# **environmental statement**

## **DAVIS - BESSE NUCLEAR POWER STATION**

DOCKET NO. 50-346

**March 1973**

- ★ Community with Zoning
- ☆ Community with No Zoning
- Cross-Hatched Townships Have Zoning

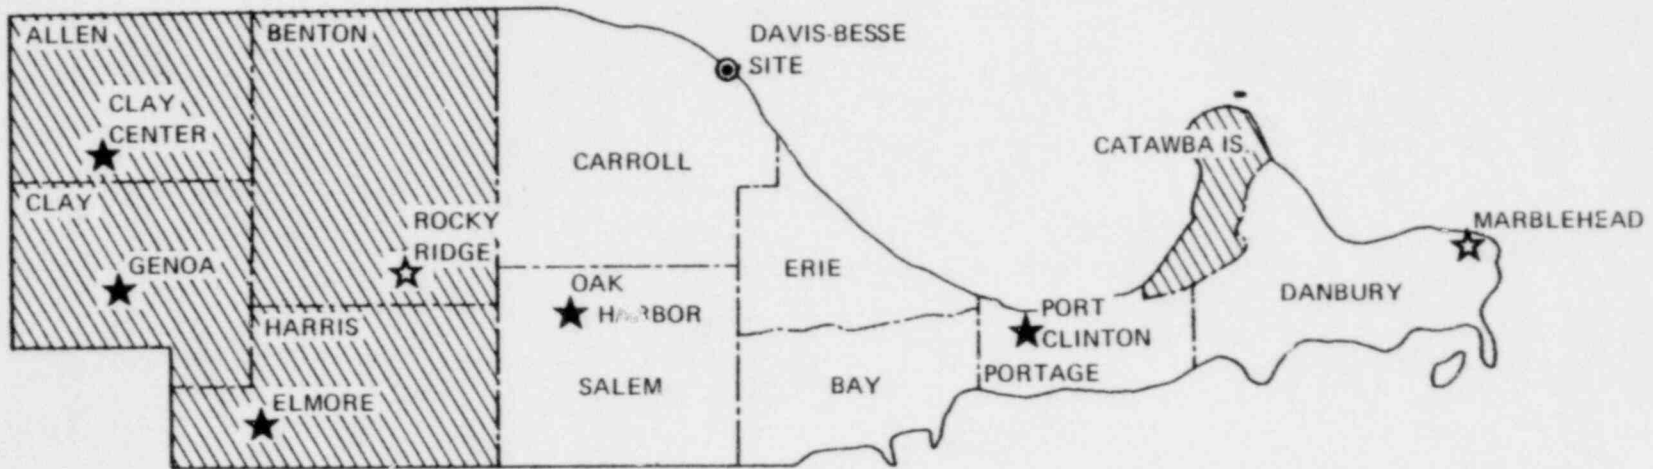
Comment: (12) According to records of the Ohio Department of Economic and Community Development, Figure 2.8 on page 2-14 is in error to the extent that the community of Rocky Ridge does have local zoning.

According to records of the Ohio Department of Economic and Community Development, Figure 2.8 on page 2-14 is in error to the extent that the community of Rocky Ridge does have local zoning.

Fig. 2.10  
SEASONAL WIND ROSES  
DAVIS-BESSE - 300 FT. LEVEL  
( '68 - '70)

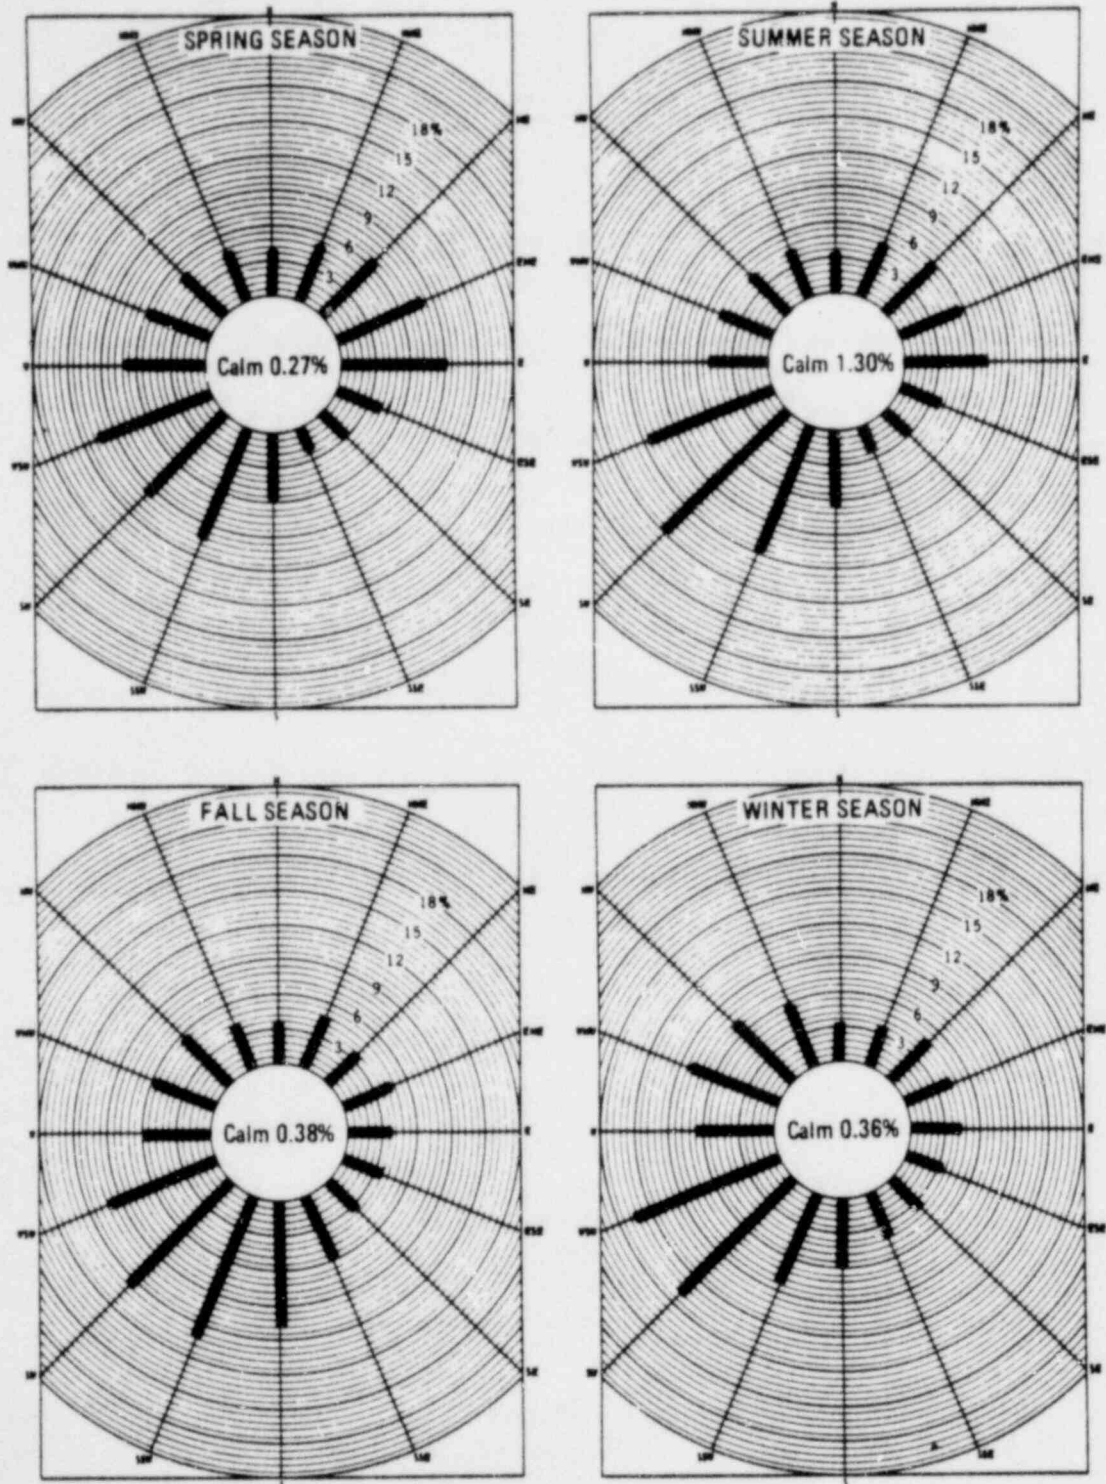
Comment: (11) The Staff does not indicate the meteorological data used and the resulting average relative concentration which we need to make a quantitative evaluation. If the releases are from roof top vents, then the wind data presented in figure 2.10 for the 300-ft. level would not be appropriate without modification.

are from roof top vents, then the wind data presented in figure 2.10 for the 300-ft. level would not be appropriate without modification. For similar reasons, we are unable to evaluate the environmental effects of postulated accidental releases of radioactive gases.

Fig. 3.5. Station Water Use Diagram.  
(Schematic only - not piping diagram.)

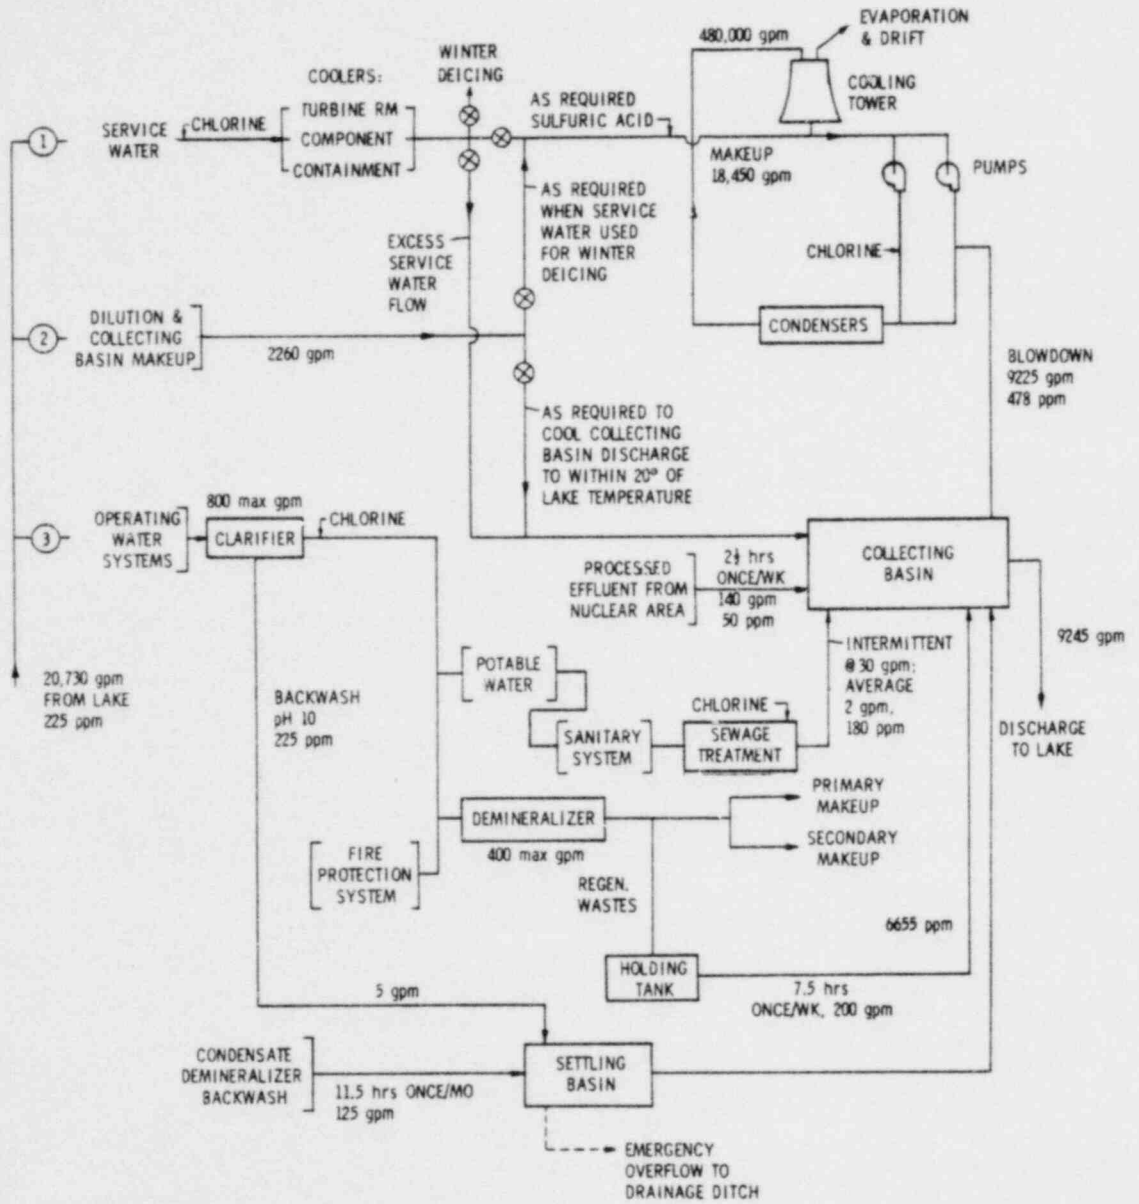
3. The station water use diagram indicates production of potable water using a clarifier and chlorine. This potable water line is shown to be interconnected with the sanitary system, fire protection system, and a demineralizer. Specific information should be given for the design and production capacity of the water use system, the methods of water purification, and the method and dosage for disinfection. Protection against contamination from backflow and/or interconnection with other systems should be clearly outlined. A flow diagram of the proposed system should be included in the final statement.

Response: Figure 3.5 has been revised to provide a better understanding of the Station's water usage. This figure is not intended to show the detailed water flow pathways or the exact system interrelationship. The Applicant has obtained the required permits from the Ohio Department of Health (See 1.3.2), and the Staff's evaluation is that the environmental impact will be negligible (Section 3.6 and 10.6).
